1999 Arapaho Road Construction Shop
Drawings

Arapaho Rd Const Meeting

3-4-99

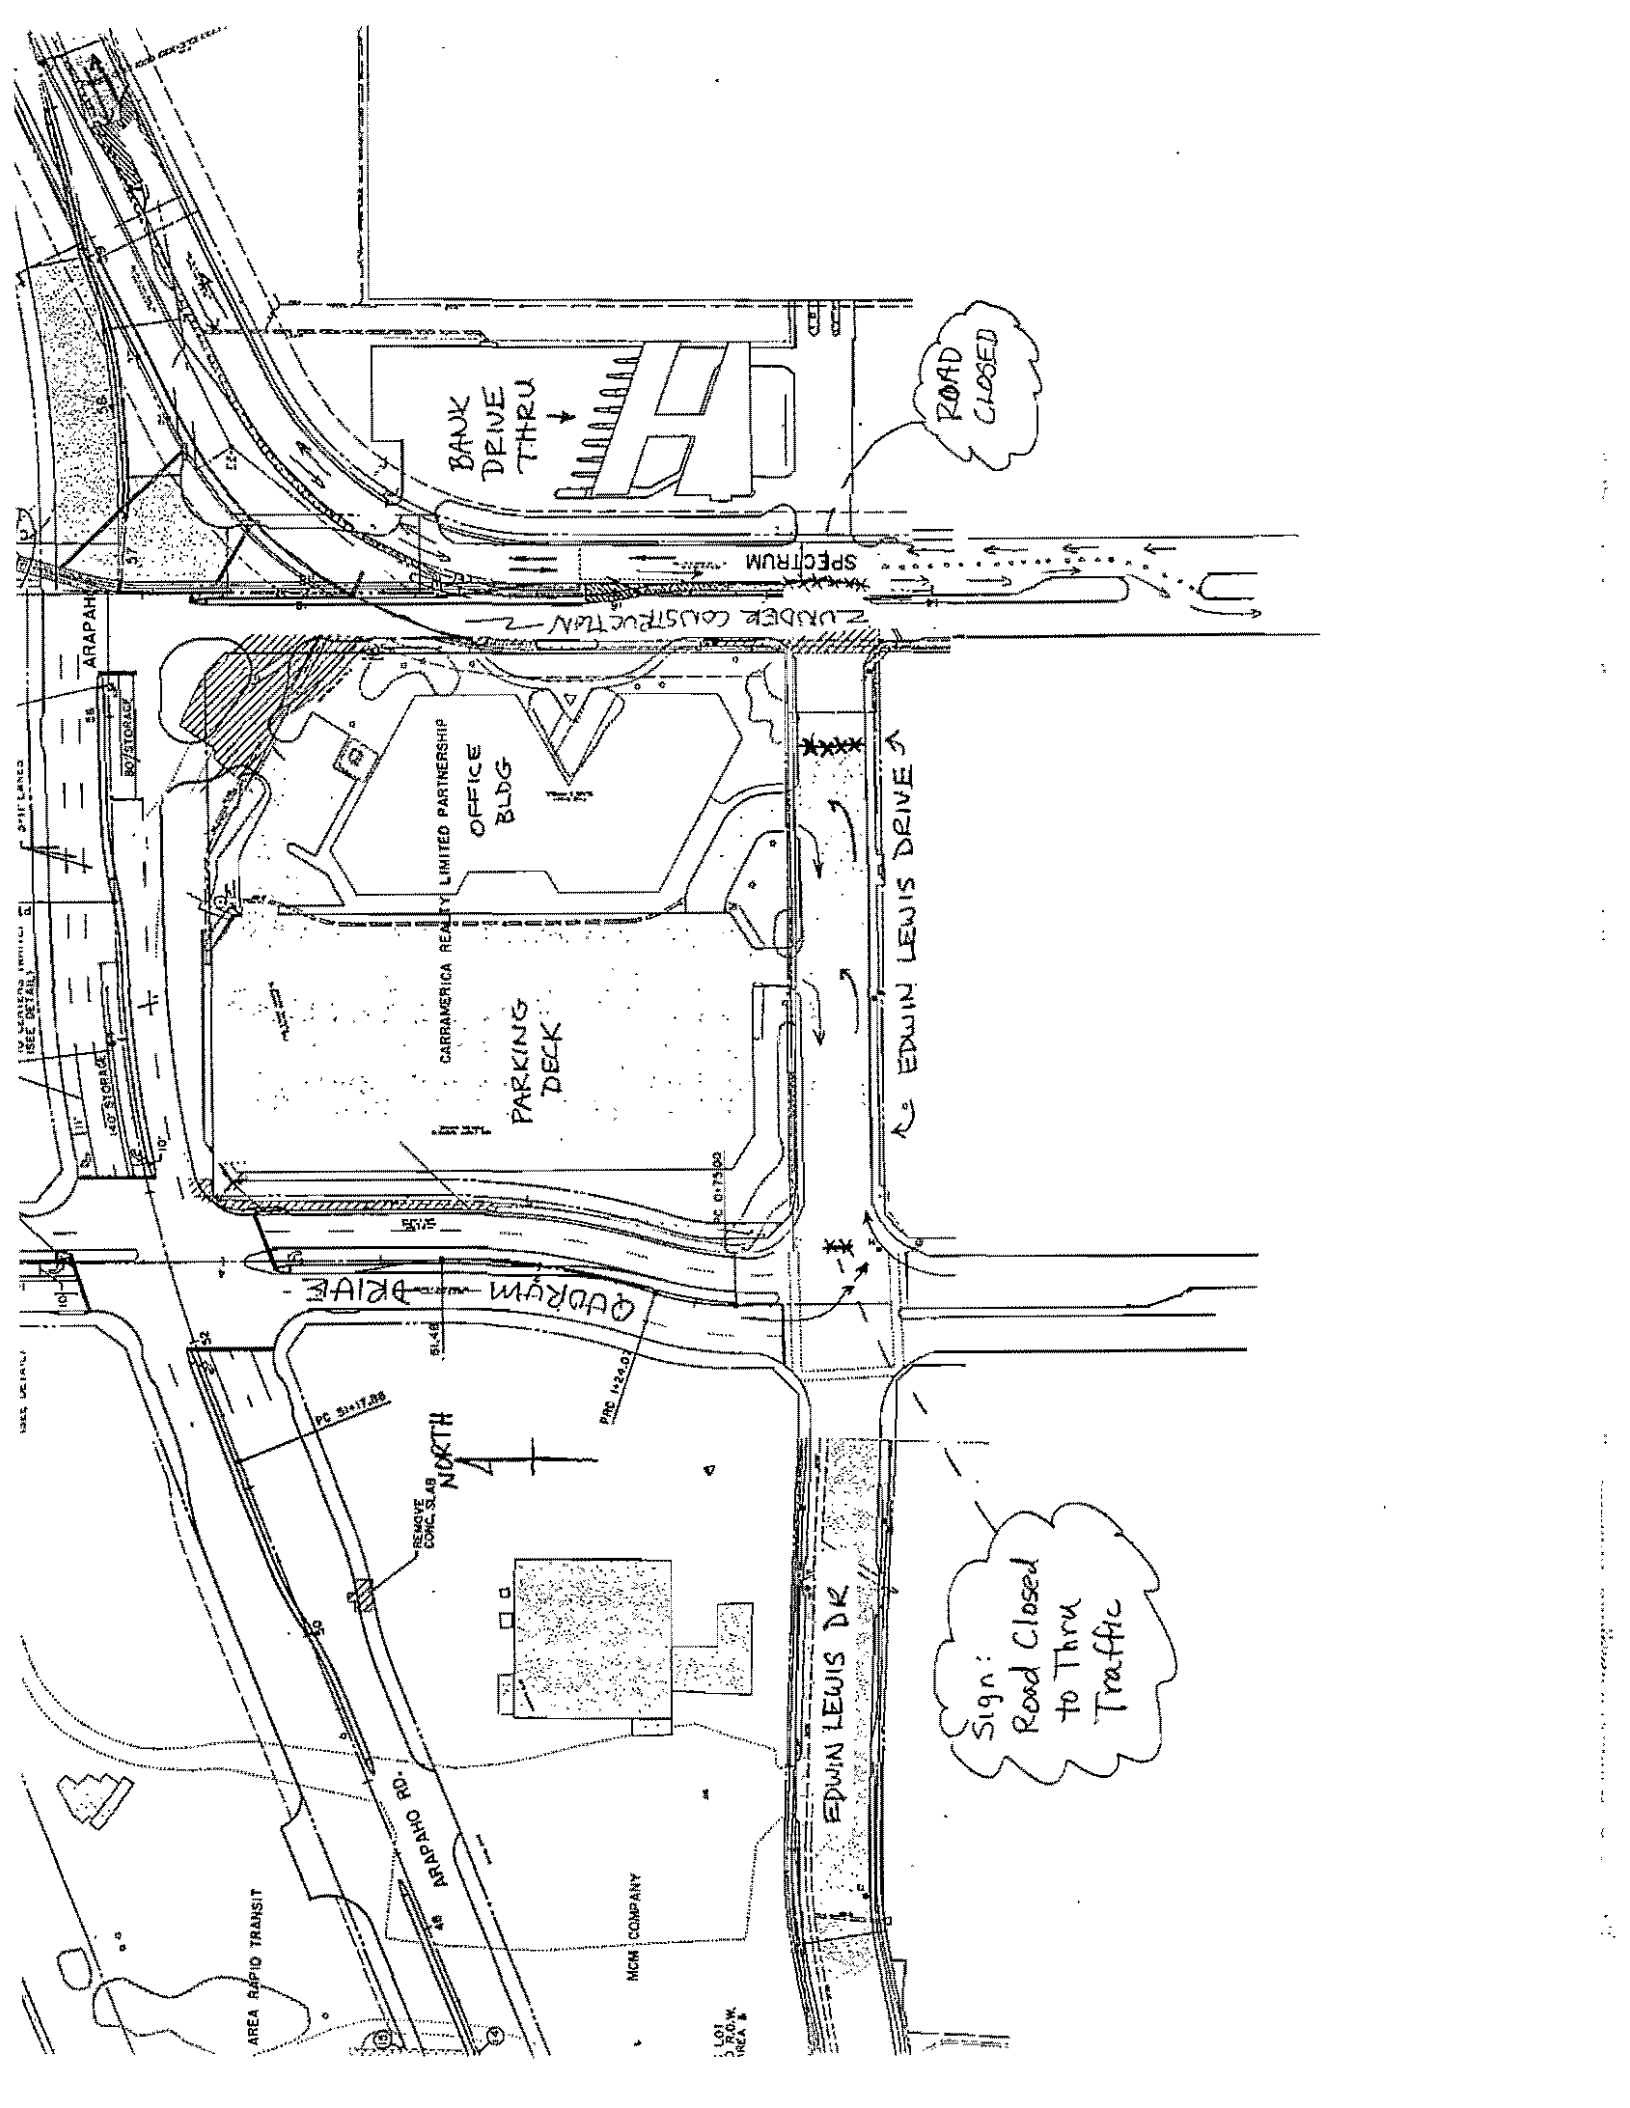
Comments: We have revised the contractor's
traffic plan re partial closure of
Edwin Lewis/Spectrum. The revised
plan provides access to your parking
from Edwin Lewis, but closes Edwin
Lewis to thru traffic. Deliveries
can continue access as they do now.
Pat Rivera is passing out the revised
plan (attached) right now ^{in the building.} Sorry for
the inconvenience but we think this
will work best.

CUSTOM CONCRETE BOLLARD

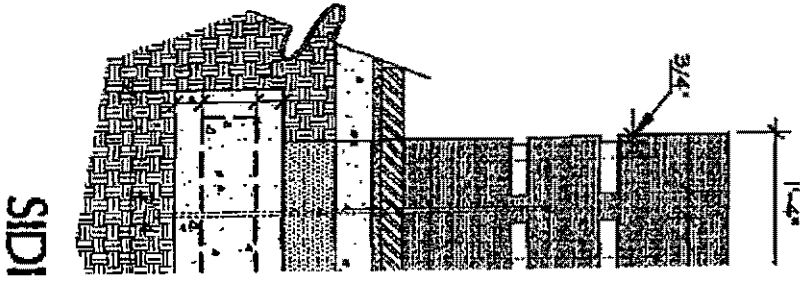
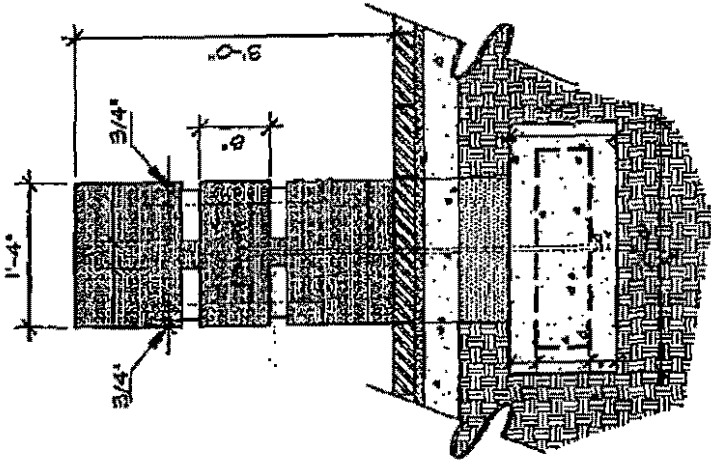
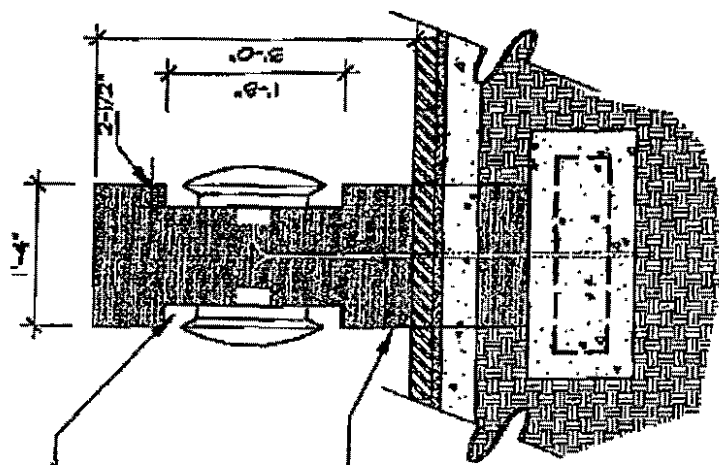
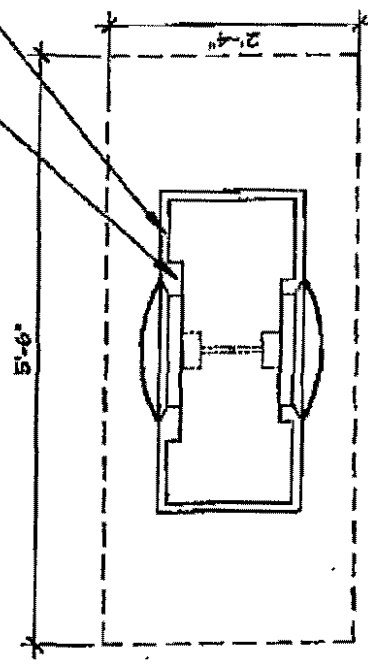
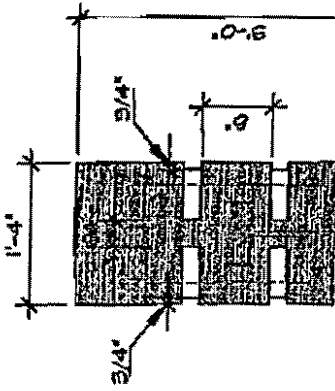
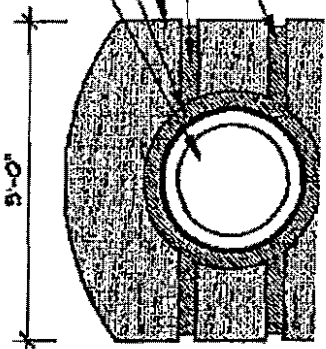
COMMENTS: FOLLOWING ARE THE REVISED DETAIL ~~DRAWINGS~~
DRAWINGS FOR THE BOLLARDS & LIGHTS ON
THE ADDISON STREETSCAPE PROJECT. PLEASE
CALL IF YOU HAVE ANY QUESTIONS. THANKS.
There are pages including cover letter. Please respond if all pages are not received.

NOTE: ALL CORNERS TO HAVE 1/2" RADIUS
 BOLLARDS TO BE PRECAST CONCRETE, SANDBLAST FINISH,
 WITH COLOR TO MATCH SIDEWALK
 JUNCTION BOX FOR LIGHT FIXTURE TO BE CAST INTO BOLLARD

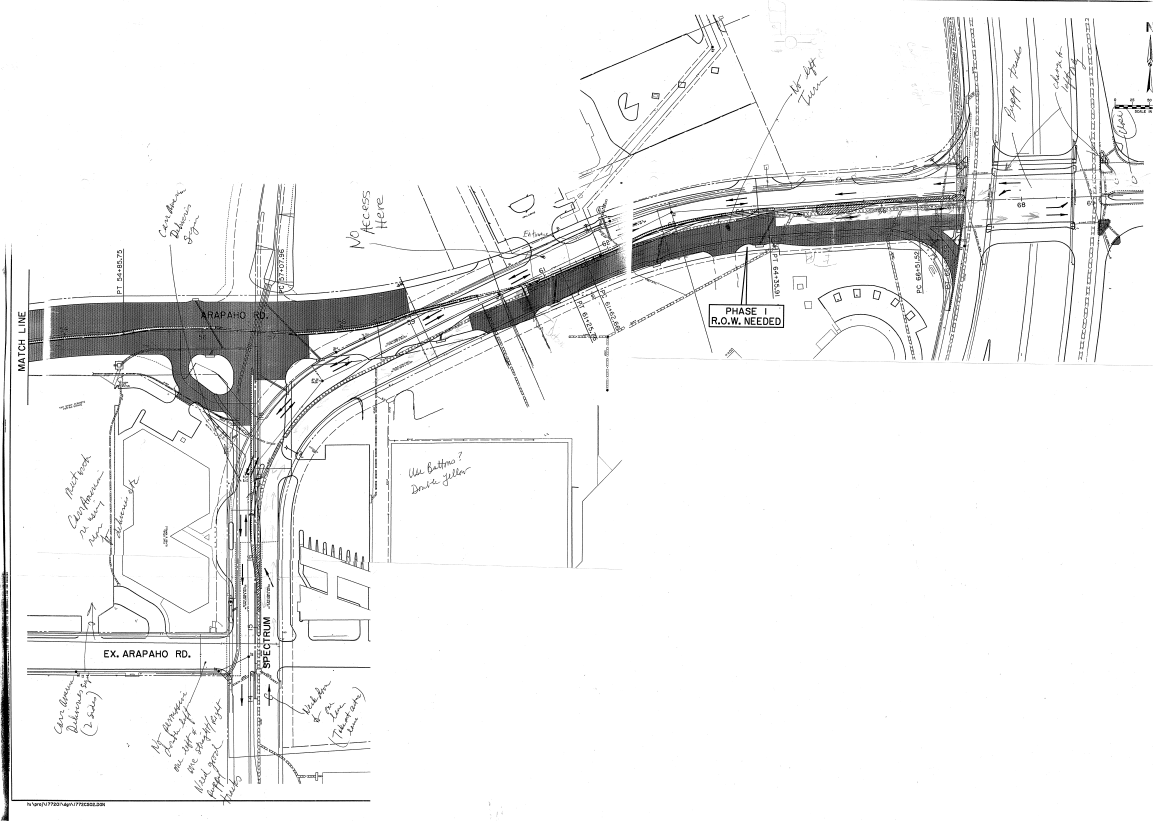
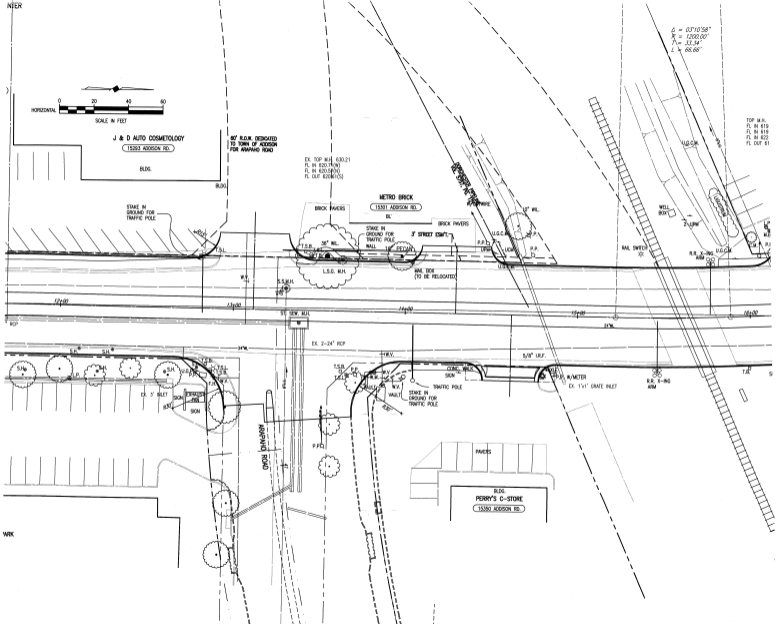
TU Installed new pipe -

Clogged up inlet

Not draining now

Both Contractors equally responsible
for the clogg.
